REMARKS

On February 21, 2001, Applicant filed an Amendment (the "Prior Amendment") to a prior Office Action (the "Prior Office Action") dated August 21, 2000. In the Office Action of May 8, 2001, the Examiner objected to the sufficiency of the Prior Amendment in response to an objection to the disclosure and to a rejection of claim 47 under 35 U.S.C. § 112, second paragraph. Responsive to the statements in the Official Action, Applicant has herein amended certain portions of the specification and claim 47.

B. Drawings

VERSION WITH MARKINGS TO SHOW CHANGES

FIG. 16

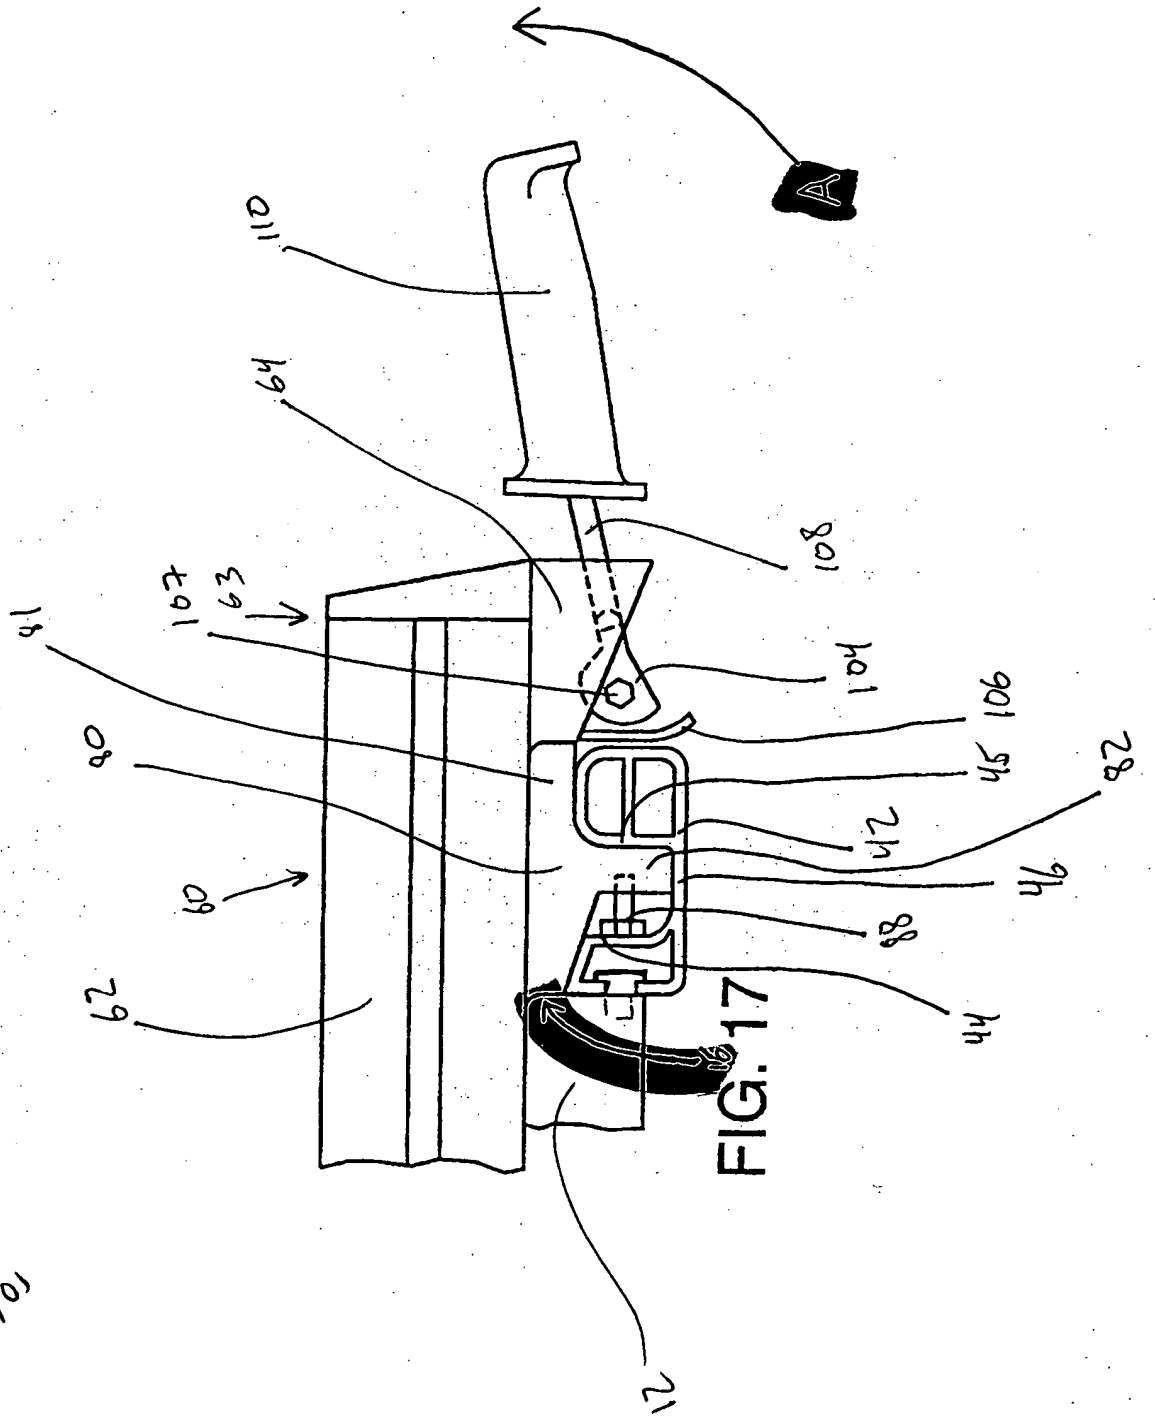
Figure 16: Reference number "64" lead line amended to terminate with an arrow and redirected to point to the proper element.

Reference number "88" lead lines both amended to terminate with an arrow.

Reference number "66" added with a lead line terminating with an arrow to show the element as supported in the original disclosure.

FIG. 19

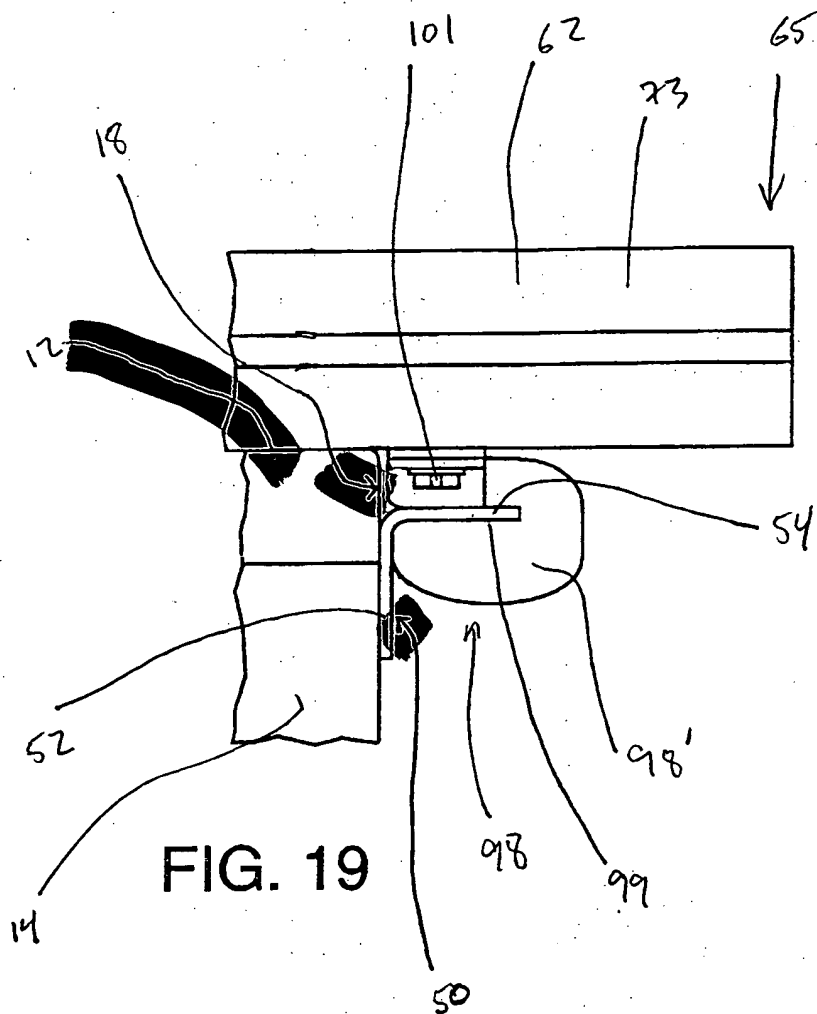
Figure 19: Reference number "12" lead line redirected to point to proper element surface.

Reference number "18" amended to terminate with an arrow and to point to proper element surface.

Reference number "50" lead line amended to terminate with an arrow.
